**NSLPP MEETING HELD ON 06/12/2023****Attachments:**

**APPLICATION No:** DA123/23

**PROPOSAL:** Installation and operation of a freestanding advertisement structure for the purposes of Council communication and third-party advertising

**RECOMMENDATION:** Refusal

**Figure 3: Photomontage**

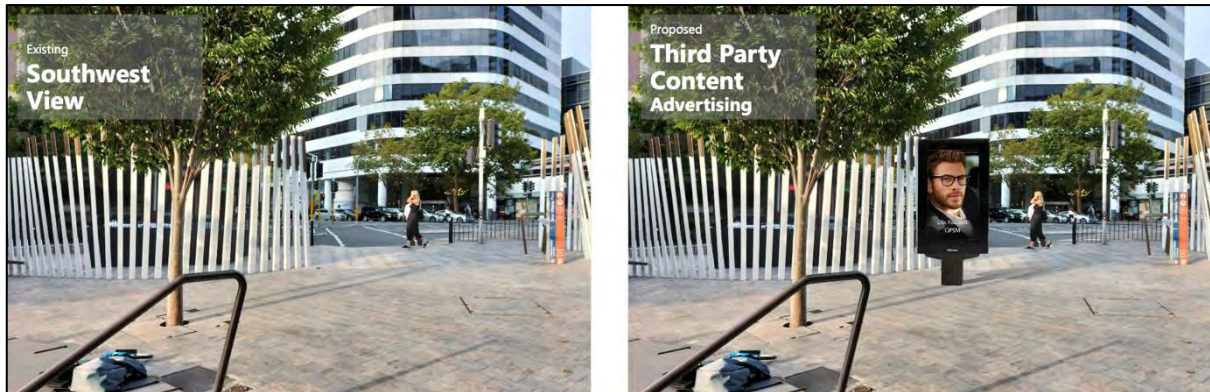
*"Heritage buildings are highly valued for their historic character and sense of place. The advertising pillar will dilute and disrupt the character formed by the group of North Sydney heritage items by the introduction of a contemporary element into the streetscape. The proposed advertising pillar will be particularly visually intrusive to the former bank at 51 Mount Street, when brightly coloured content and/or dynamic advertising is displayed.*

*The advertising pillar and its associated content will render the streetscape less authentic and subject to commercialism. Heritage items have a sense of reliability, trustworthiness and constancy. This contrasts the very nature of advertising which is used to typically promote products that are of a transient nature such as fast fashion or of an addictive nature such as alcohol. Advertising in the context of so many heritage buildings associated with banking, postal services, a court and insurance will be incongruent and detracting.*

*The advertising pillar has been designed to be a visual distraction from the experience of the streetscape and will draw attention away from the heritage facades and other static elements in the streetscape that represent an unchanging environment which the community has agreed to protect. During night time, the pillar will contribute to light pollution which will further degrade the character of the streetscape.*

**Figure 5: Footpath width**

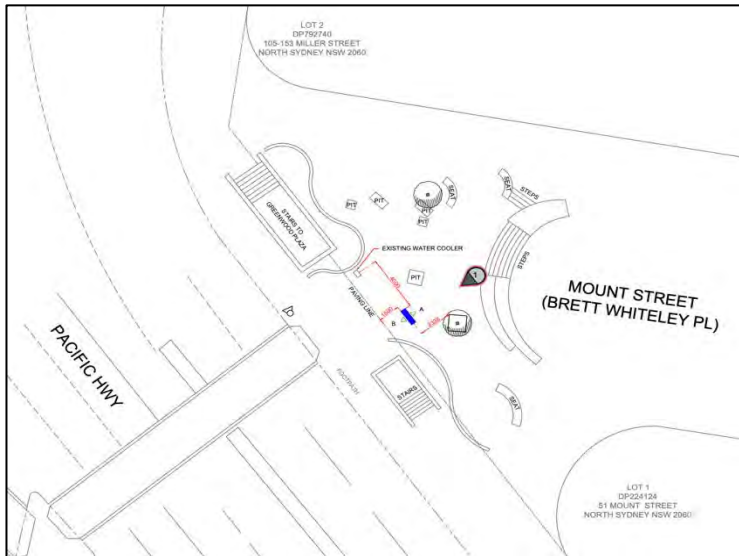
It is considered that the location of the panel between the existing artwork and its proximity to a very busy pedestrian crossing would unreasonably impact on the direct pedestrian path of travel. The Panel reduces the available footpath width by 1.2m. Moreover, it forces pedestrian to navigate between the panel; the artwork and the existing tree when traveling east. Introducing another decision making obstacle to navigate. In addition, it significantly reduces the accessible path of travel clearances.
